Round 7 - Dam Assessment Report

Lansing Generating Station

**Interstate Power and Light Company (IPL)
Lansing, Iowa**

Dewberry, LLC
Fairfax, Virginia

Figure 6.1 Drainage basin areas.

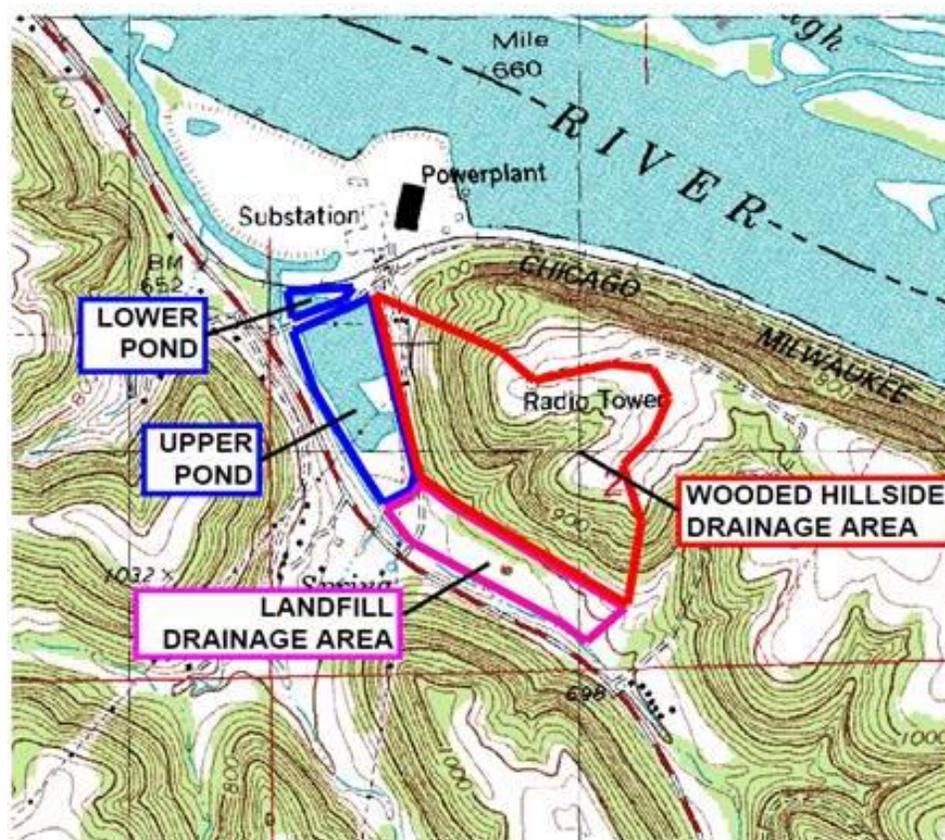
The peak inflow from the adjacent and onsite basins is about 210 CFS which is routed through the storage of the two ponds. The ponds attenuate the inflow with an estimated discharge into the Mississippi River of 27 CFS with a peak Ash

Figure 7.2 Static Conditions modeling using SLOPE/W

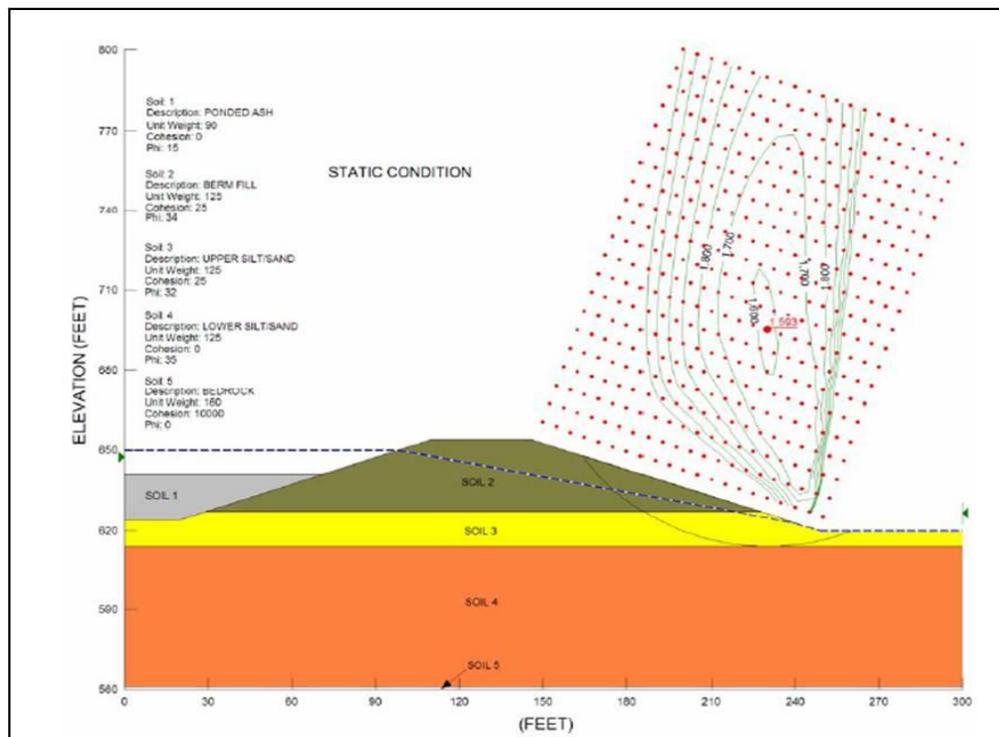
Static Analysis - The minimum FS obtained with the established phreatic surface within the dike was 1.59 (Figure 3). This value exceeds the minimum acceptable FS of 1.5 and is acceptable.

Seismic Analysis - The minimum FS obtained from the pseudo-static seismic analysis was 1.53 (Figure 4). This value exceeds the minimum acceptable FS of 1.15 and is acceptable.

Rapid Drawdown Analysis - The minimum FS obtained from the sudden drawdown condition was 1.22 (Figure 5) with the pond ash level at El. 635 feet. This value is within the acceptable minimum FS range of 1.1 to 1.3. At pond ash levels higher than El. 635, the FS will exceed 1.22.

Figure 8.1 Lansing Site Aerial Site Plan

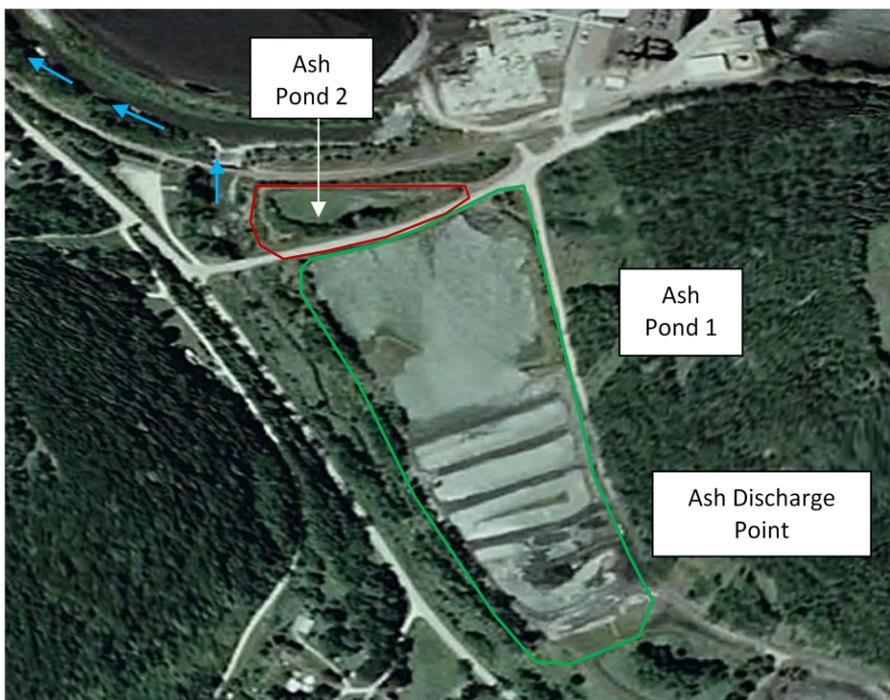
Ash Pond 1 receives bottom and fly ash at the most southerly portion of the pond. As the effluent flows northward through the channelized portion of the pond, the ash settles and is periodically excavated. Other plant effluent is also discharged including boiler wash water, plant site storm water runoff from the land fill, cooling tower blow down, plant floor drains. Other plant wastewaters discharged into Ash Pond 1 for treatment including the following: non-chemical boiler and turbine wash and rinsate waters, boiler blow-down, steam grade water production wastewaters, plant floor drains and storm water runoff from the landfill (see Figure 8.1).

Documentation of an operations and maintenance plan was not provided to Dewberry for review. Based on observations made during the site visit, the Ash Pond 1 west side dike needs to have many trees removed along the outside slope and toe. The easterly portion of the dike appears to be in good condition. The southerly side is adjacent to the landfill and receives runoff from the landfill through a 24 -inch CMP culvert that discharges directly into the pond.

FIGURE 3

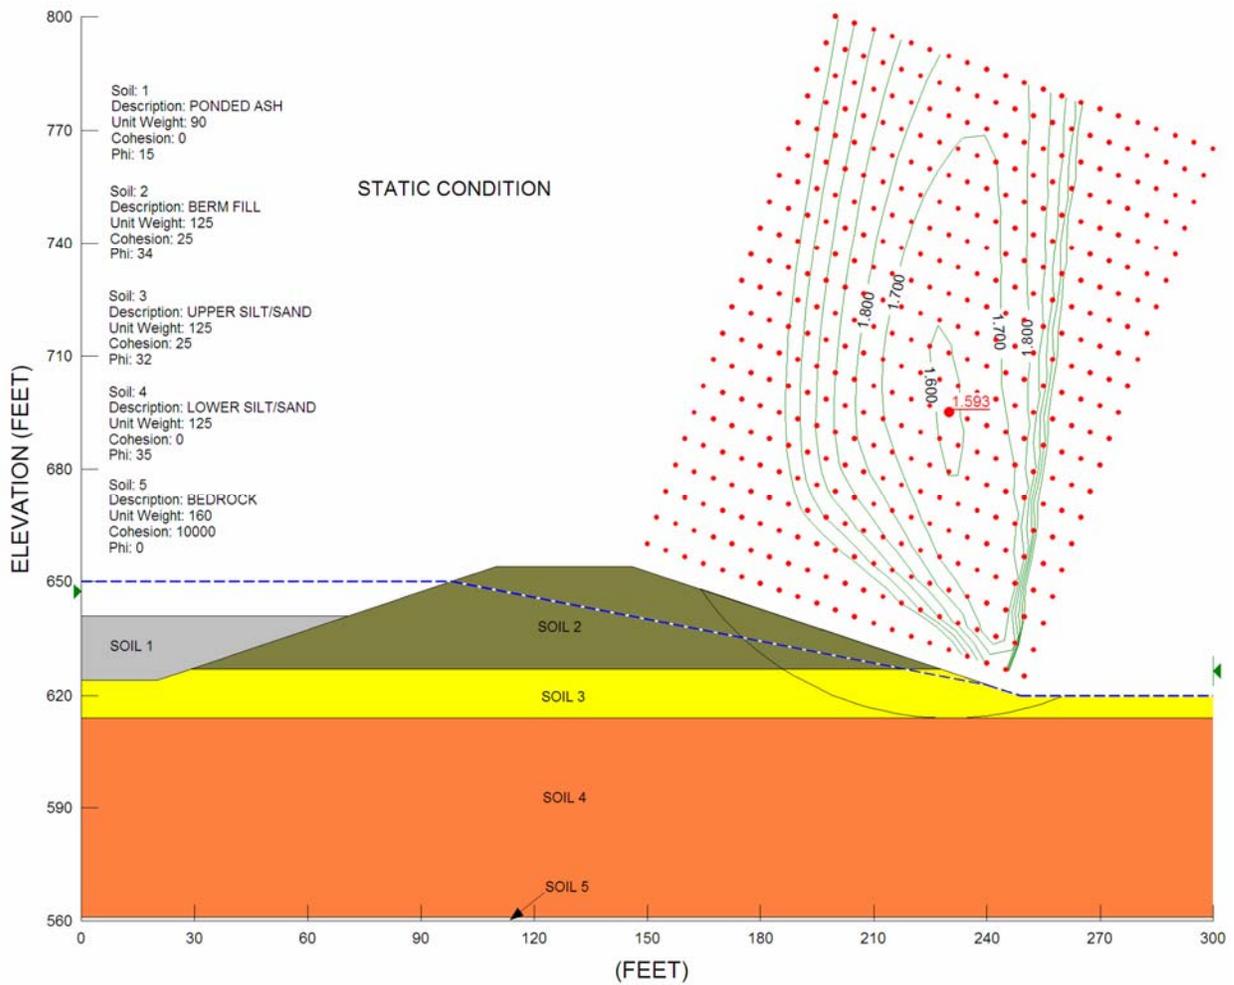
The minimum FS obtained with the established phreatic surface within the dike was 1.59 (Figure 3). This value exceeds the minimum acceptable FS of 1.5 and is acceptable.

FIGURE 4

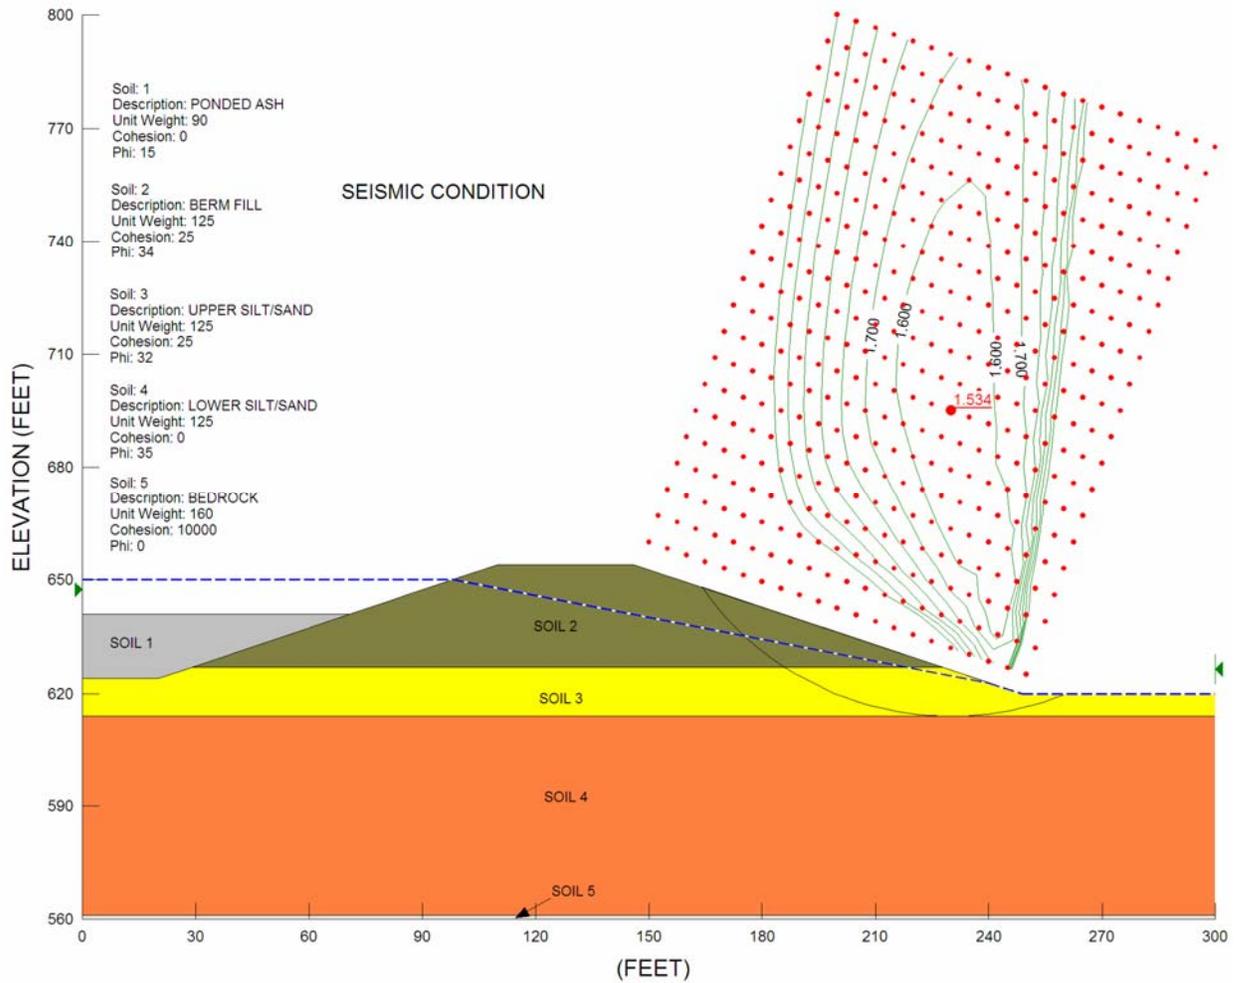
The minimum FS obtained from the pseudo-static seismic analysis was 1.53 (Figure 4). This value exceeds the minimum acceptable FS of 1.15 and is acceptable.

FIGURE 5

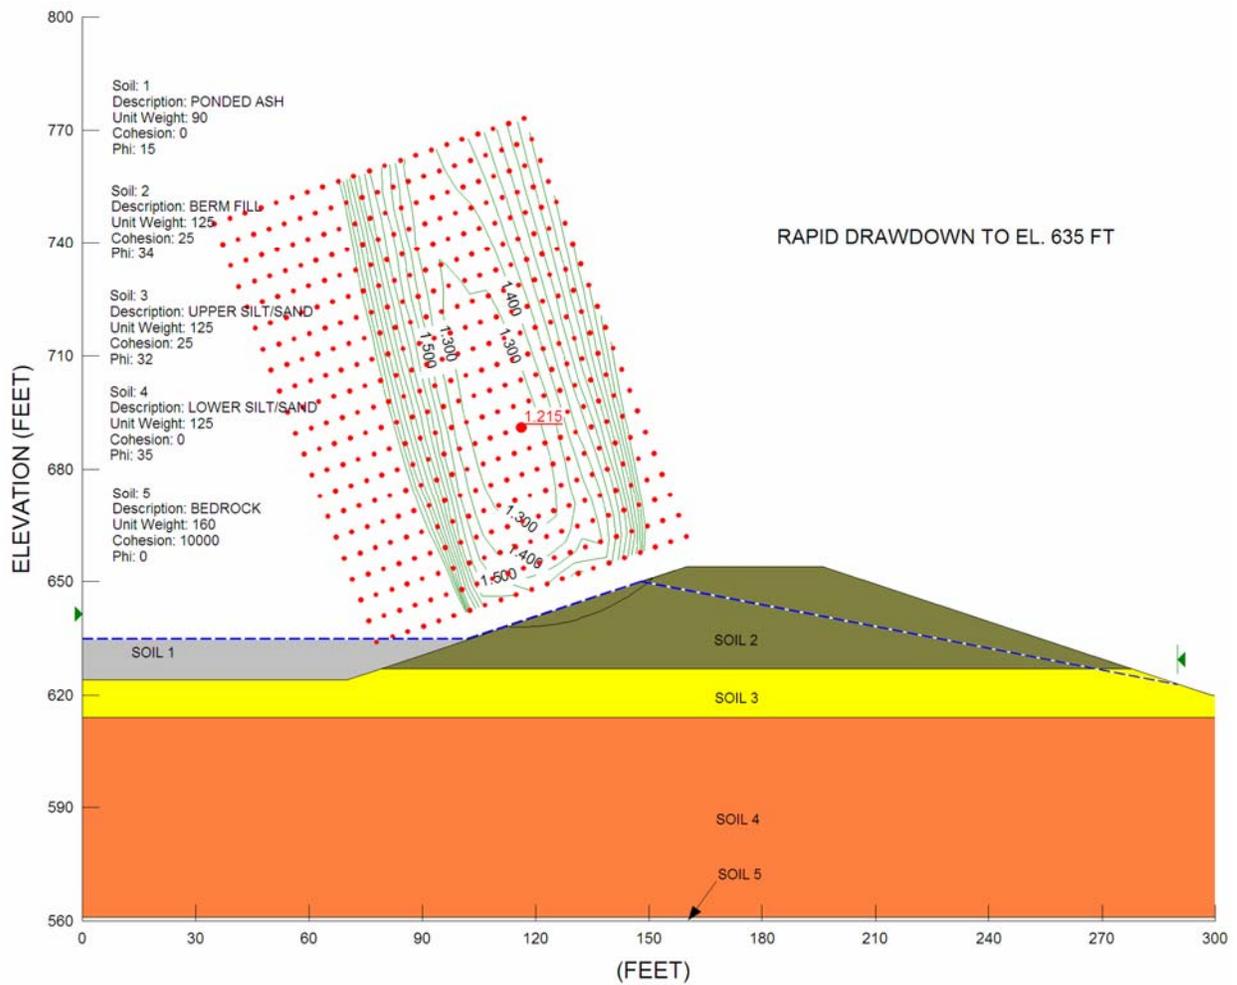
The minimum FS obtained from the sudden drawdown condition was 1.22 (Figure 5) with the pond ash level at El. 635 feet. This value is within the acceptable minimum FS range of 1.1 to 1.3. At pond ash levels higher than El. 635, the FS will exceed 1.22.
